28 July 2016

File No: 2016/401214  
Our Ref: R/2015/18/A

**RE: LEES 1 Science Research and Teaching Facility (SSD 7054) and F23 Administration Building (SSD 7055) – The University of Sydney**

**Figure 1:** Aerial view of Eastern Avenue and proposed development (shaded yellow)

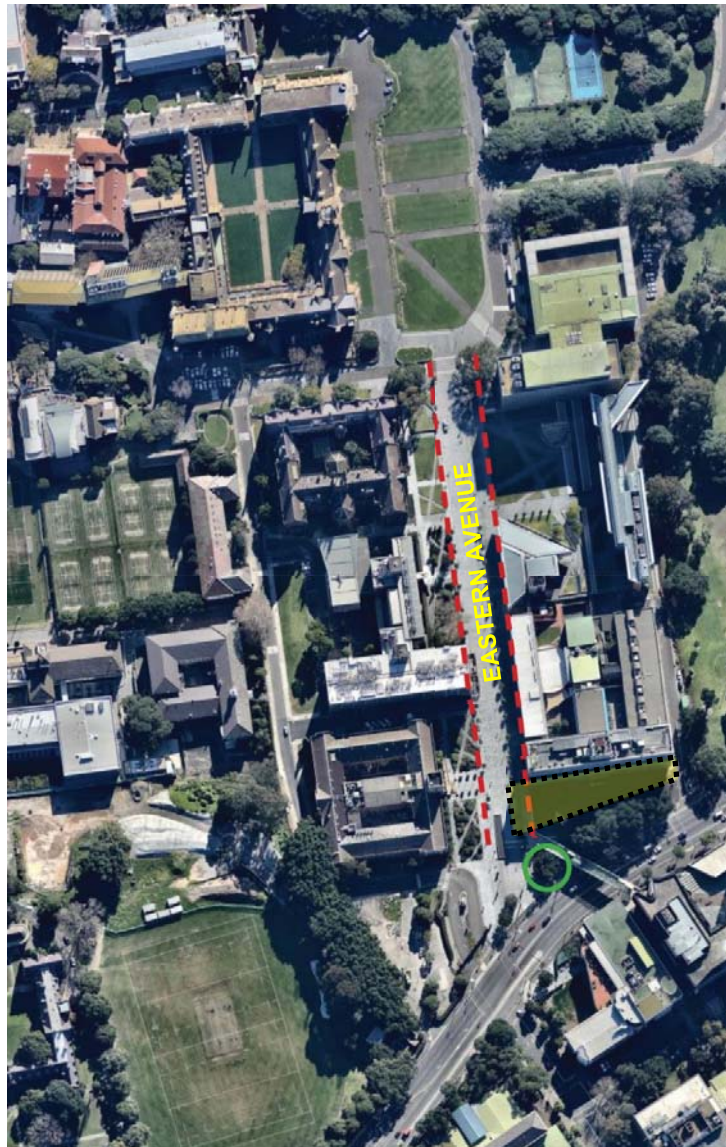
The Eastern Avenue view corridor is currently unimpeded by development and generally maintains a consistent eastern alignment (Refer **Figure 1** & **Figure 2**). Whilst the proposal respects the alignment at its lower levels, Levels 5 – 8 will protrude two metres beyond the alignment of the adjoining Carslaw Building and the established axial arrangement along Eastern Avenue (**Figure 3**). This is the University’s principal north-south axis.

Contrary to the views of the proponent, the eastern side of Eastern Avenue maintains a strong vertical alignment. This is an important device in maintaining the spatial qualities and gravitas of Eastern Avenue, contributing to the identity of the place. Any erosions in the alignment will weaken the strength of the grand vista which connects the campuses. The vista should not be terminated by the proposed building encroaching into the alignment; in the future, the Fig tree planted at the southern end of Eastern Avenue (**Figure 1** - circled in green) will suitably terminate the vista.

The City does not agree the proposed justification satisfies the threshold established by the CMP for breaking the alignment, that is, “extraordinary circumstances”. It is therefore recommended that the upper levels of the Eastern Avenue elevation are redesigned such that the building, in its entirety, does not protrude beyond the alignment of the adjoining Carslaw Building.

**Figure 3:** View looking south along Eastern Avenue demonstrating proposed encroachment into eastern alignment

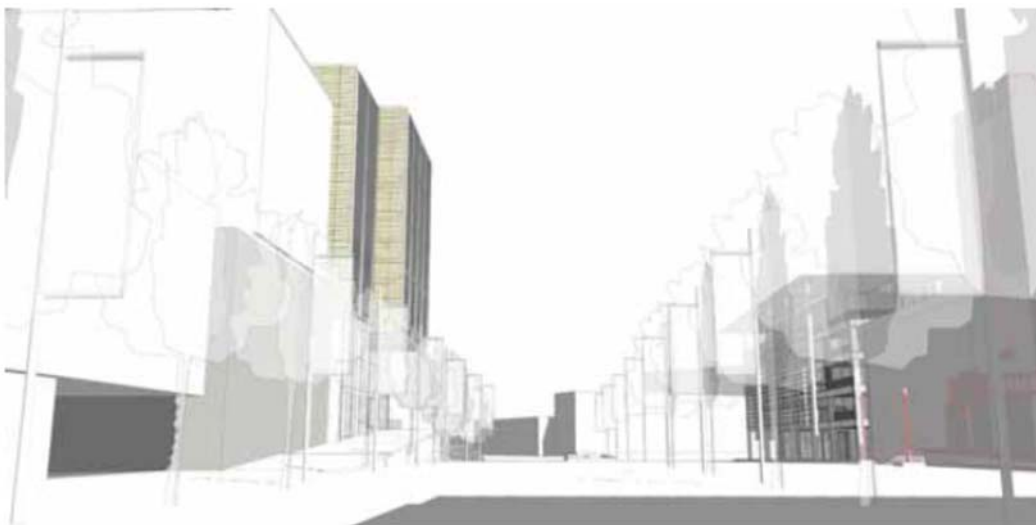
As illustrated in **Figure 2**, the existing condition and straight vertical silhouette against the sky will be lost through encroachment of the upper levels of LEES 1. Despite previous concerns raised by Council and the NSW Heritage Division regarding this encroachment, the development has only partially addressed the issue. It is however noted that the applicant provides justification for the encroachment, having the requirement for “larger upper level floor plates” to accommodate future research uses.

**Figure 6:** Lower Entry Level to LEES 1 (L) and Upper Entry Level to LEES 1 (R)

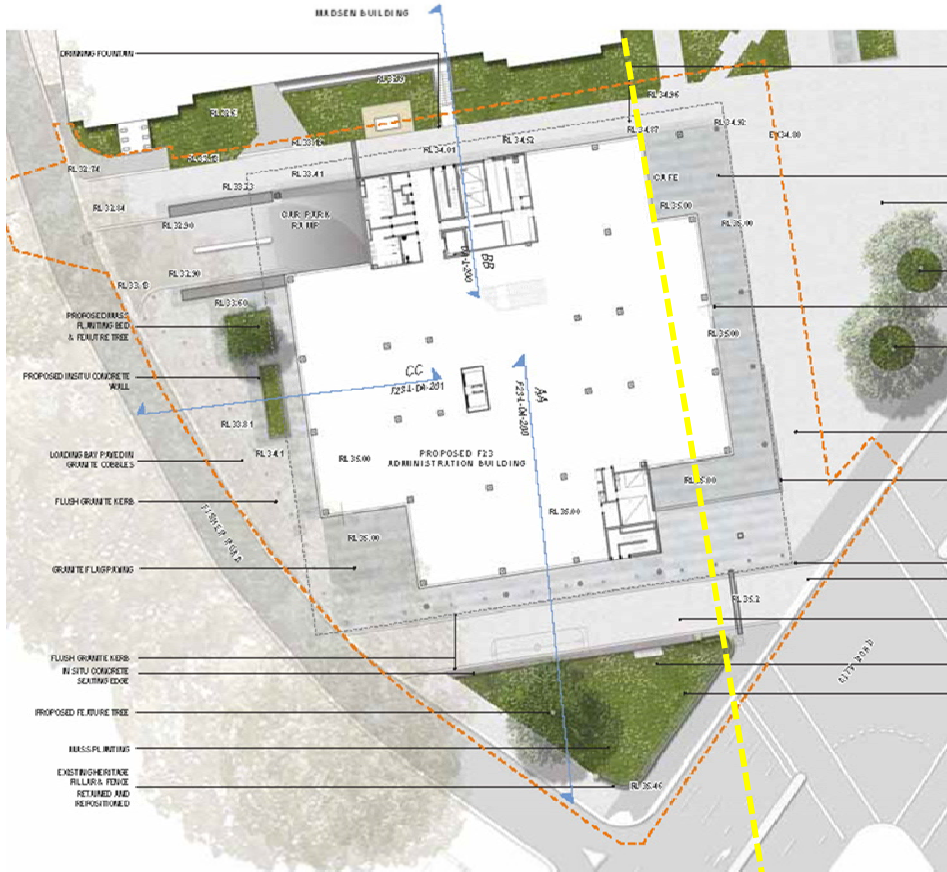
The render over page illustrates the proposed secondary alignments with the Madsen Building. The areas shaded in yellow are aligned vertically. As can be seen from the view below, the alignment of a setback façade on the proposed building with the primary alignment of the Madsen Building is irrelevant as the primary bulk of the proposed building is established by the strong horizontal projecting slab edges, the vertical portico columns and the overhanging roof.

It is recommended the preferred eastern alignment for the F23 building respects the primary façade alignment of the Madsen Building. In addition, given the close proximity of the proposed building to the Madsen Building (approximately 10m), it would be preferable for the northern elevation to acknowledge the bulk and form of the Madsen Building architecturally, perhaps by referencing a similarly solid form to the same height as the main parapet line. This is indicated above by the red shaded section of the northern façade on the above render.

The northern façade should be modified to reflect the bulk and form of the adjacent Madsen building. The modification should reference the more solid and vertical proportions of the Madsen Building.

**Figure 8:** 'Gateway Plaza' illustrating desired lines and pinch points

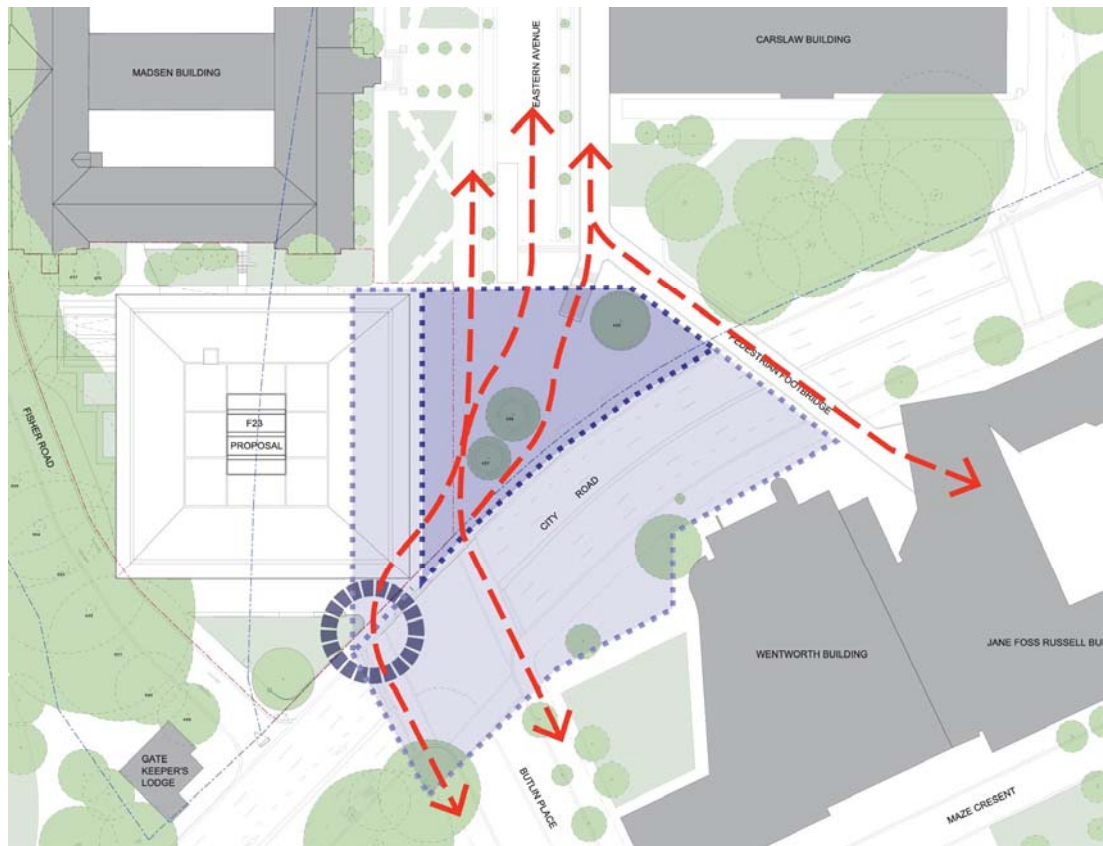
Figure 8 below illustrates the key pedestrian routes (shown in red) through the gateway plaza. There are three routes for pedestrians to cross City Road between these campuses- two on grade at the traffic lights, and one footbridge connecting the Carslaw and Wentworth buildings.

For this space to form a successful gateway plaza, a clear network of pedestrian routes must be formed that reflects the inherent desire lines. The darker blue shape indicates the physical plaza that exists, and the lighter blue area beyond indicates the wider space and connections that this gateway must encompass. The diagram illustrates the impacts of the building on this plaza, which are as follows:

- (a) A pinch point is created between the south-east corner of the building and City Road. The alignment/projection of the building constricts the pedestrian route leading from Eastern Ave to the westernmost pedestrian crossing, and across to the western section of the Darlington campus.
- (b) The triangle of land to the south of the building has limited function, and is only formed as the result of the footprint- not as a logical landscape space.

- (c) The function of the western-most pedestrian crossing is reduced, as the drop-off lane reduces the space for a group to wait without blocking the footpath (blue circle). This crossing may currently be secondary to the one to the east, but will increase in use when the campus improvement program is implemented for the western portion of the Darlington campus.

- A. Realign the building footprint to align with the Madsen building façade, thereby encompassing the western pedestrian crossing within the gateway plaza and removing the pinch point at the south-eastern corner of the building;
- B. Continue the asphalt paving of the City Road footpath across the vehicle threshold;
- C. Reconfigure or remove the steps to the base of the F23 building to remove this projecting corner from the public domain. The alignment and connection to City Road should read more strongly than the building footprint in this are;
- D. Ensure pedestrian priority is maintained regardless of the traffic requirements for the drop-off/emergency lane:

**Figure 3 (recommendations):** Drawing F23-L-DA-100, extract from Arboricultural Impact Assessment (PREFERRED).

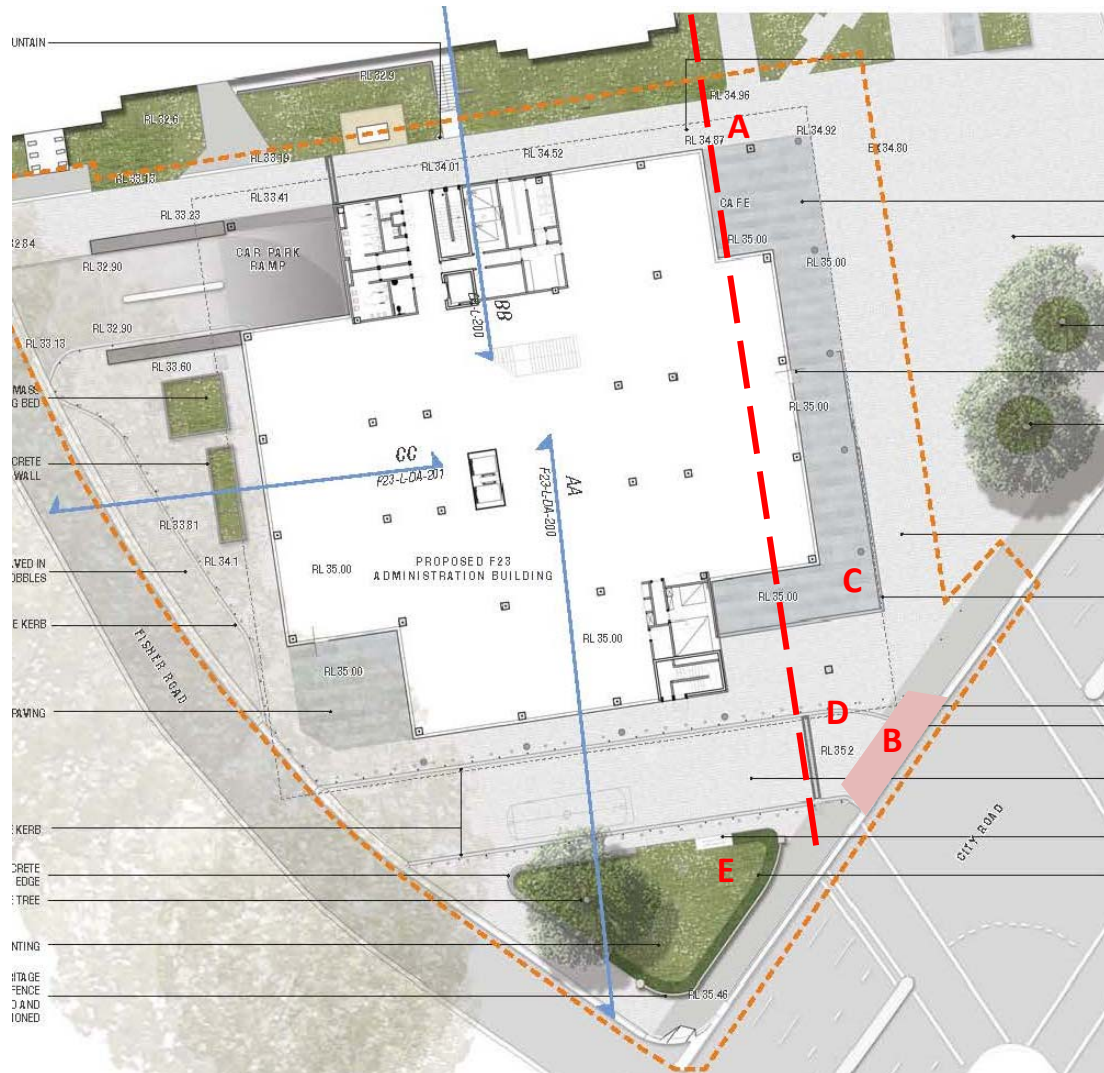
The hard landscape at ground level is very much in response to the building footprint, rather than the wider urban connections. The flag paving to the base of the building follows the alignment of the roof above, instead of creating a continuous pedestrian network. This results in awkward material junctions, leftover landscape spaces, and a disconnected pedestrian route. It is noted however, that the Arboricultural Impact Assessment (AIA) includes a landscape plan that differs from the plan in the landscape set (**Figure 9**). The plan in the AIA shows a much more continuous public domain, and is preferable.

- Ensure the traffic control measures e.g. boom gates do not interrupt the pedestrian routes.
- Ensure that both the levels and paving material form a continuous public domain leading from Eastern Avenue to both sides of the City Road pedestrian crossing.

E. Retain the current alignment of the heritage wall to slightly reduce the size of the triangular planted space. Ensure the design incorporates this space as a logical landscape element, not just leftover space.
